Name of Work Constructing an Hospital with outhouses at Pungamur, North Arcot Dist.

14TH SEPTEMBER 1894, No. 2333 W., PUBLIC WORKS.

The Chief Engineer offers the following remarks on the plan and estimate submitted by the Superintending Engineer, IV Circle, for constructing a Local Fund hospital at Punganúru in the North Arcot district.

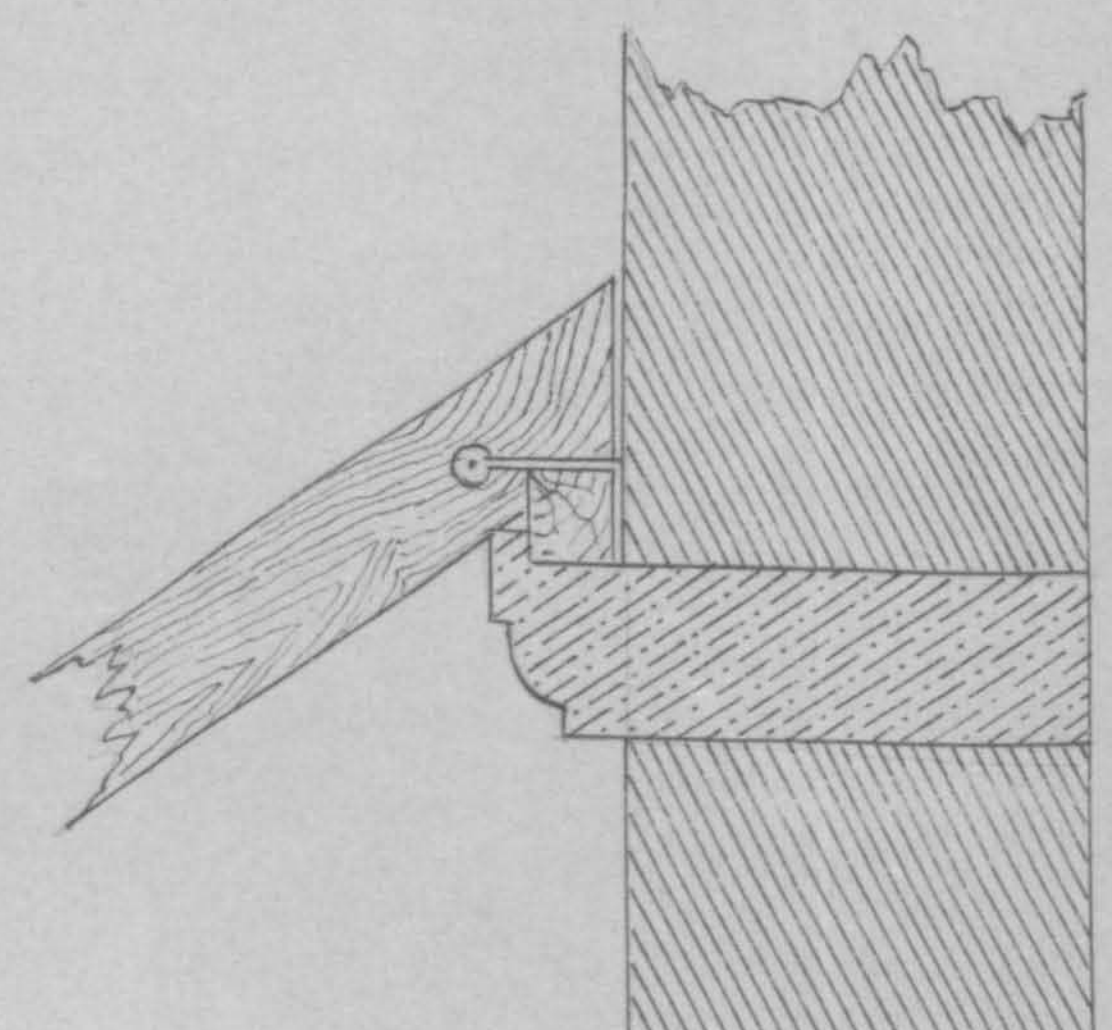
5. Instead of supporting the verandah rafters partly on bressummers carried on masonry pillars and partly on wall plates let into the wall, a wall purlin should be provided for the whole length of the verandah, carried on stone corbels let into the wall as shown in the following diagram:—

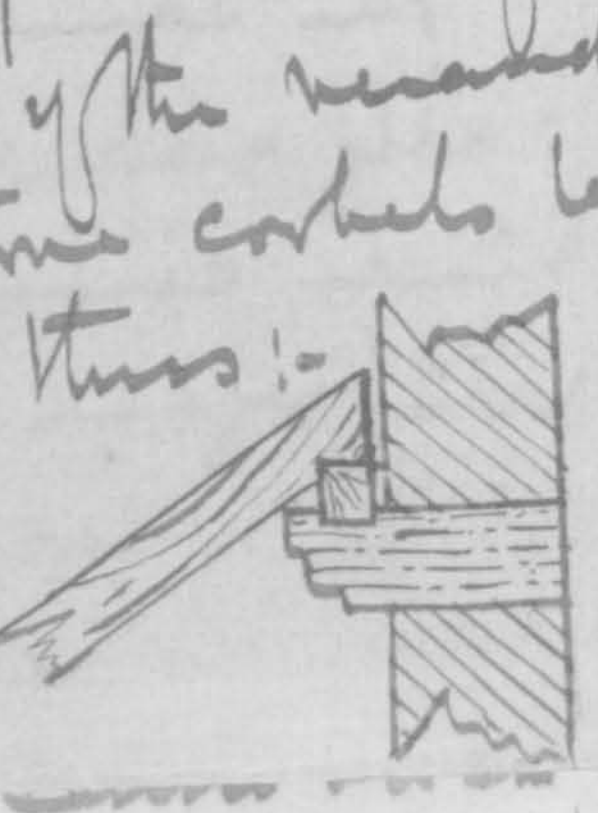
It is submitted that instead of supporting the verandah rafters partly on bressummers carried on masonry ~~posts~~ pillars & partly on ~~[illegible]~~ wall plates let into the wall, a wall purlin may be provided for the whole length of the verandah carried on stone corbels let into the wall thus:-
